COMMONWEALTH OF VIRGINIA
COUNTY OF HENRICO

RE: POD2023-00349
Gayton Village
POD Initial Review

Gayton Village

SHEET NO:
C6
JOB NO. 2301

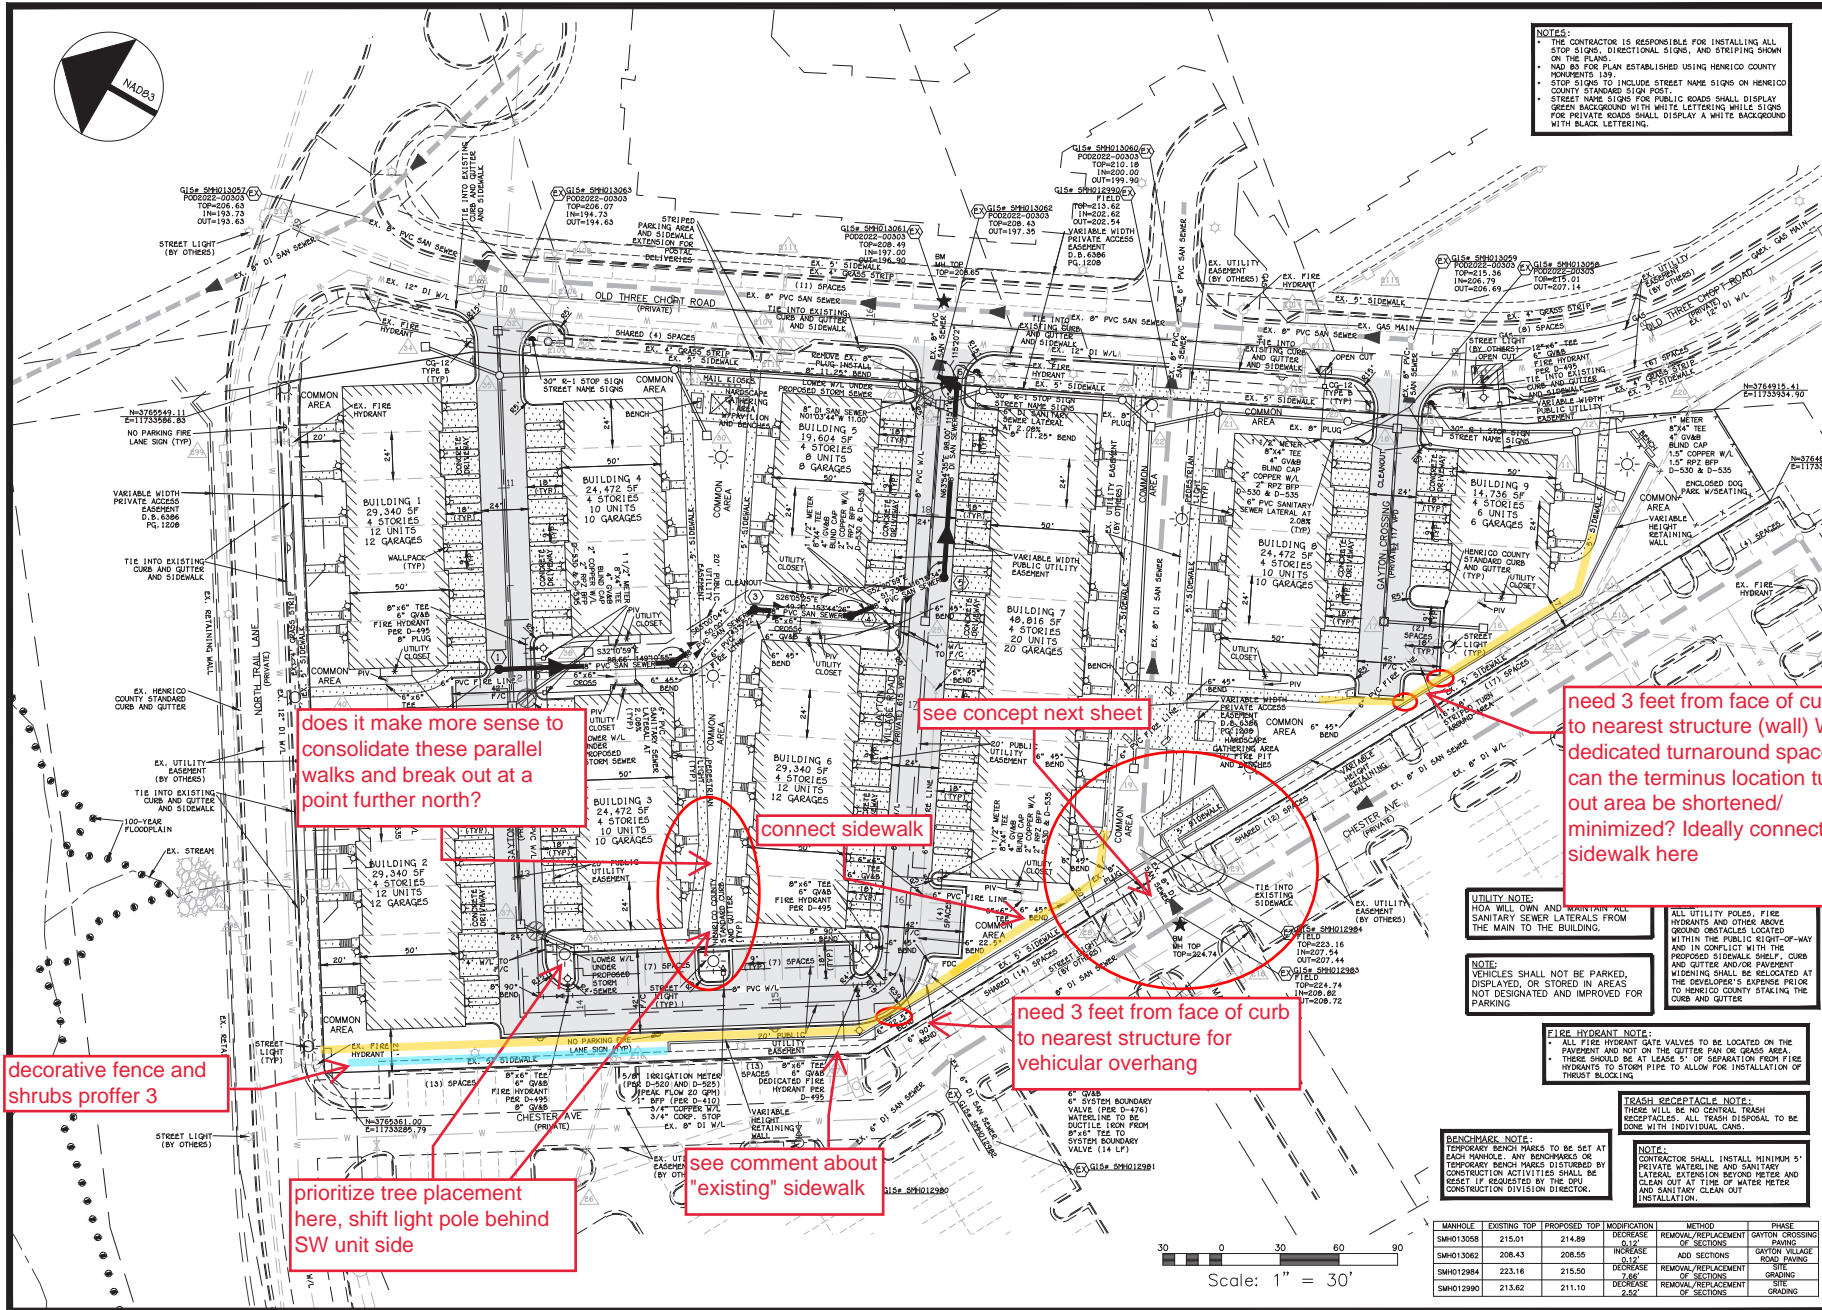
2. Details demonstrating better coordination at the point of connection to the West Village property must be received, in addition to more complete pedestrian connectivity throughout. Recommend a formal hardscape element on raised curb, including a raised planter and furnishings. See plan markup and concept recommendation on sheets following this letter to include elongating the switchback ramp at the connector location.

3. The existing sidewalk labeled at the top of the retaining wall is not detailed for construction with the West Village plans. Each plan suggests the other plan will exist, but it is not proposed with either, so this issue is outstanding. Staff recommends sidewalk be primarily provided at the bottom of the wall in lieu of a continuous sidewalk at the top of the wall (See mark up for yellow routes), which will enable better parking lot perimeter lighting and required landscape installation, in addition to any vehicular rated protection needed at the top side of the wall. If sidewalk is to still be proposed at the top of the wall, additional detail is needed to demonstrate all required elements will fit.

18. Continue to coordinate with the West Village plan revisions.
19. See following mark up and graphic included herein for clarification of items.
